Subject: BODY VIBRATION DURING EXTREMELY COLD WEATHER	Bulletin No.: 01-020/19
	Last Issued: 11/26/2019

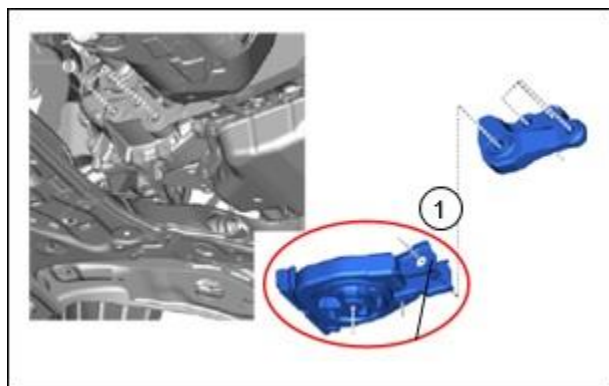
Some vehicles may exhibit an excessive body vibration when idling or driving after being left in extremely cold weather (-20°C/-4°F or below) for a long time. This is caused by the No.1 engine mount (1) rubber hardening due to material characteristics.

To correct this concern, the cold environment performance of the No.1 engine mount rubber has been increased by changing the rubber material.

- If yes, replace the No.1 engine mount rubber with a modified one according to the instructions on MGSS.
 - ENGINE MOUNT DISASSEMBLY/ASSEMBLY [SKYACTIV-G (WITH CYLINDER DEACTIVATION (US))]
 - ENGINE MOUNT DISASSEMBLY/ASSEMBLY [SKYACTIV-G (WITHOUT CYLINDER DEACTIVATION (US))]
